Findings – 5/16/2019

During the ORC review of the T1441.02 installation today at 13:00, we found:

User Cameron Dean,
5/16/2019; see photo-1

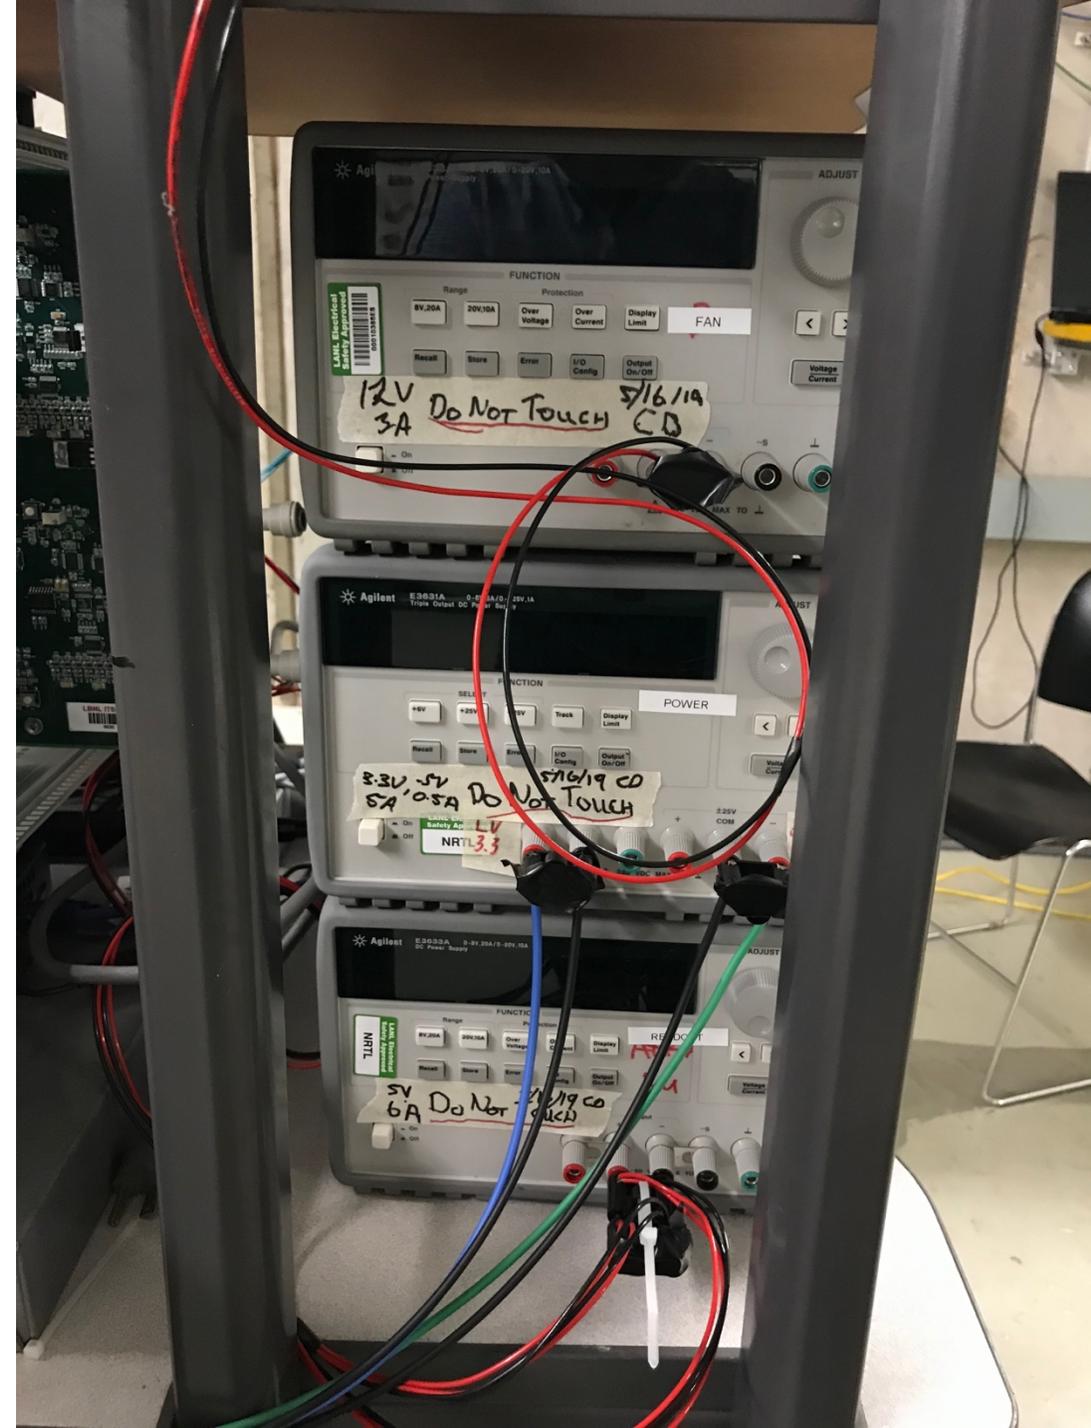
- 2) The AC power cordage, plug-ins, loading looked --OK.
- 3) The DC power supplies are using the internal presets, entered into non-volatile memory, to set the DC power voltage limits and current limits. Require that the presents be indicated on the power supplies with a label to indicate their respective presets, the effective dates, and person/persons using these presets.
Done, see attached photo-1.

- 4) The DC power distribution's fuse protection, wire sizes, etc. are sufficient for the DC power involved. --OK.
- 5) Recommend to place a tape over the power supply banana jack connections to prevent any DC shorting through these jacks. Done during the review. --OK. Also see photo-1

PS voltage and current limits
are labeled:

Top: Fan PS

- 12 V
- 3A

Middle: staves

- 3.3V, 5A
- Bias: -5V, 0.5A

Bottom: RU power
5V, 6A

Detector with cooling tubes connected Far-end location, photo-2,3

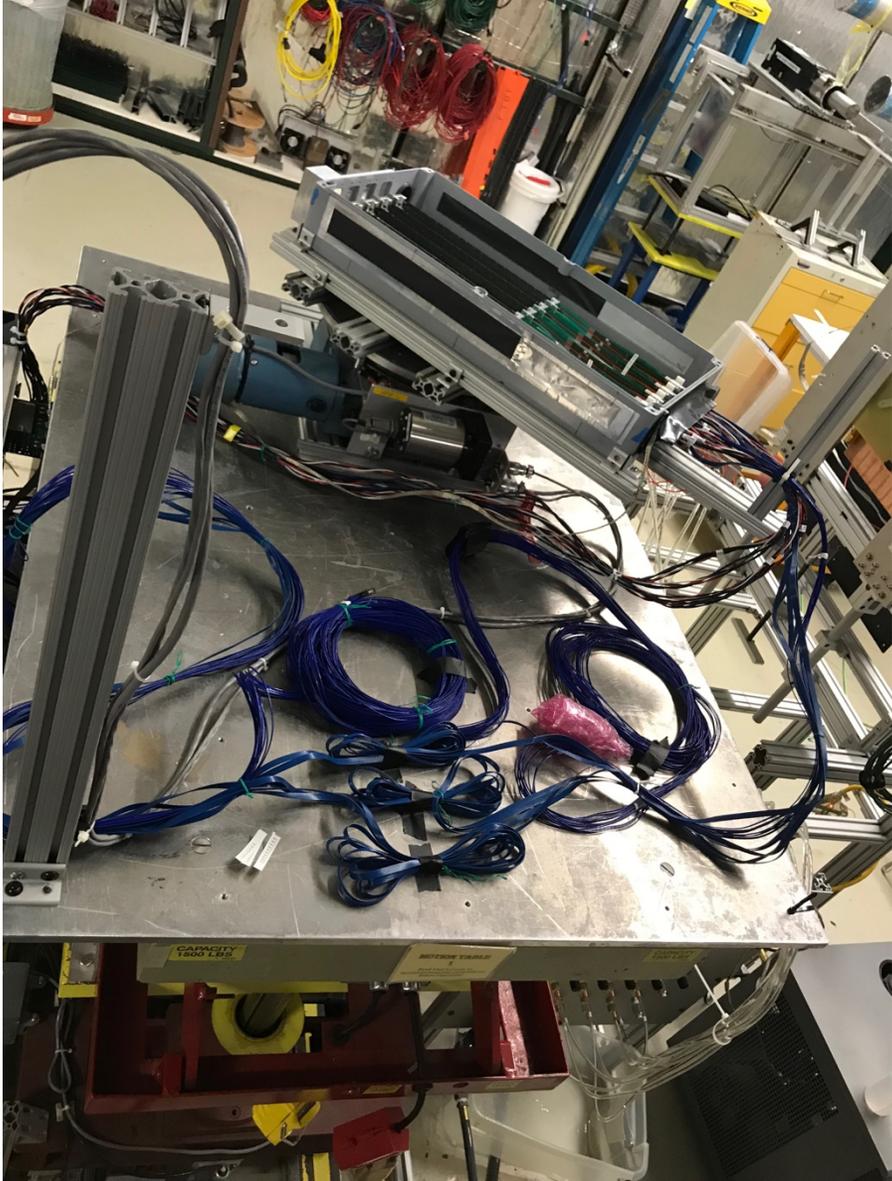
- 8) When the detector's cooling tubes are connected and tested for leaks, the table travel and planar rotation needs to be checked for proper cable and tubing slack and restraint.
Done. 1) connected and tested for leaks, 2) cable slack and restrains see photo-2,3,4,5;

- 9) The cables to the readout crate need to be grouped and restrained properly for the table travel. Once done, this travel needs to be rechecked. Done, see photo 2,3,4,5; readout cables are also taped to the table

Detector with cooling tubes

Near-end location, photo-4,5
